RE: 1st Revision to PCB Cleanup and Disposal Notification
Joseph A. DePaolo Middle School, 385 Pleasant Street, Southington, CT

I am submitting the following answers and revisions (**in bold**) to the PCB cleanup and disposal notification for the Joseph A DePaolo Middle School at the above referenced location, based on your two e-mails dated February 1, 2013:

**REVISED PCB EXTERIOR BUILDING
MATERIALS SAMPLE LOCATION MAP**

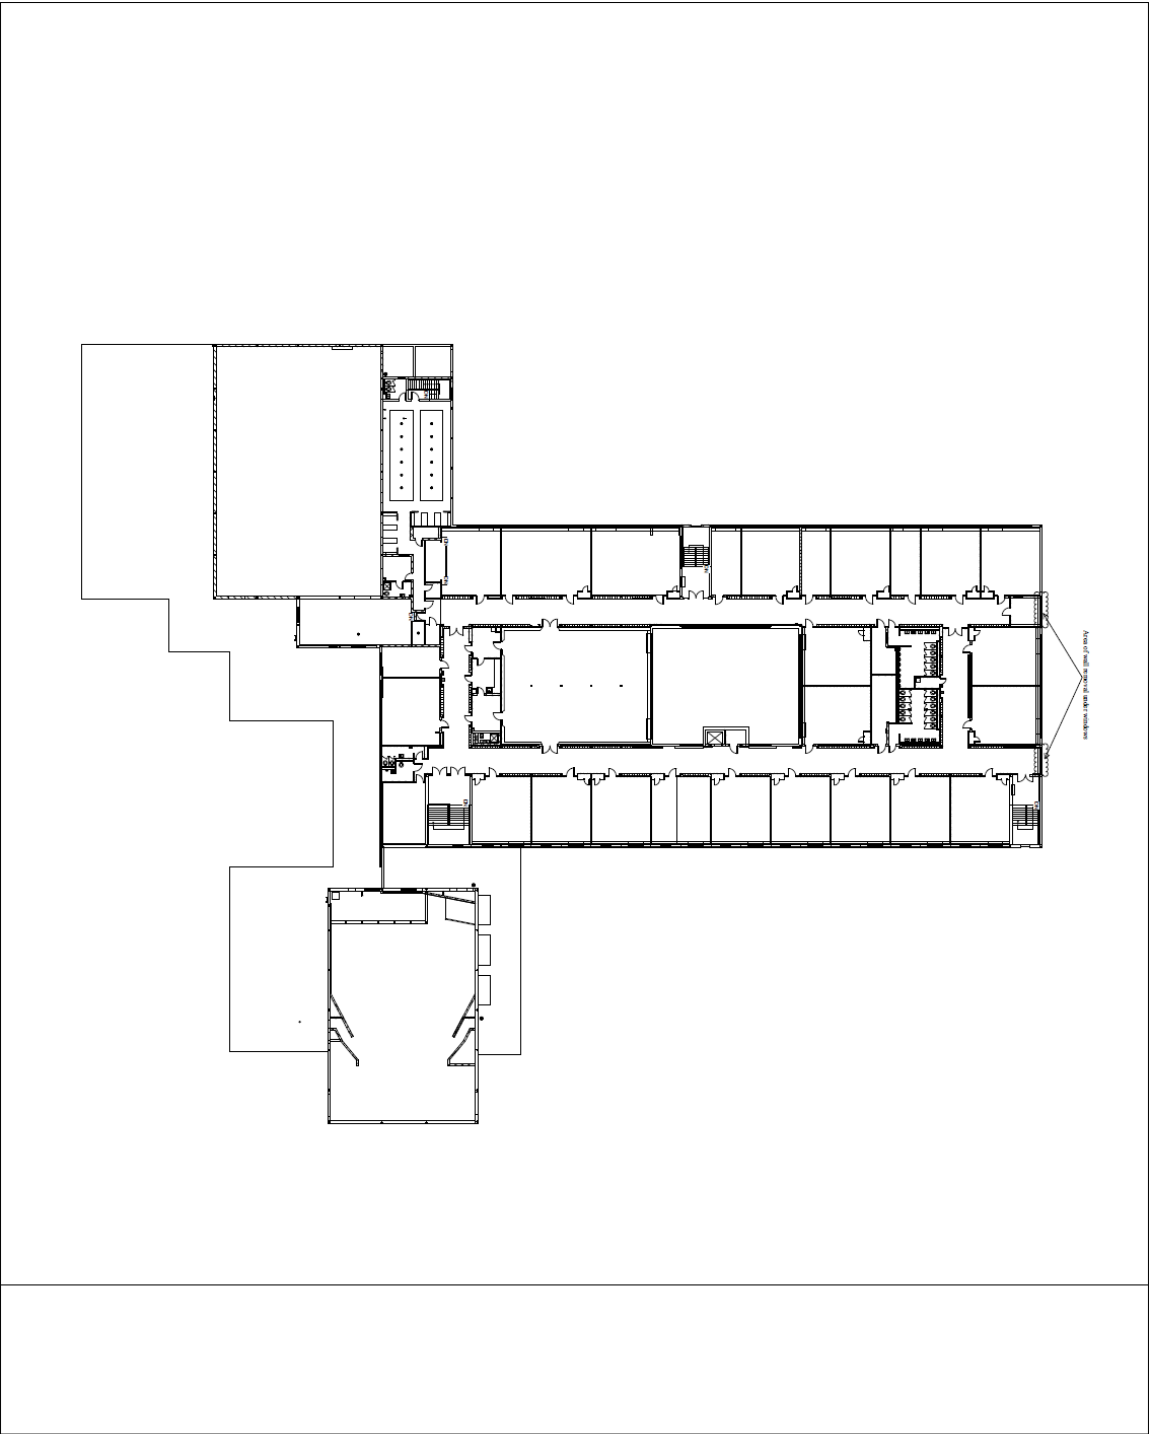
15. Following sample locations were not found on the drawings (I didn't go through every sample, so there may be others): EXTB-17 & EXTB-23. **I have added them to the EXTB map and have provided the new copy of the map for your review. There were no additional sample locations missing that I could find.**
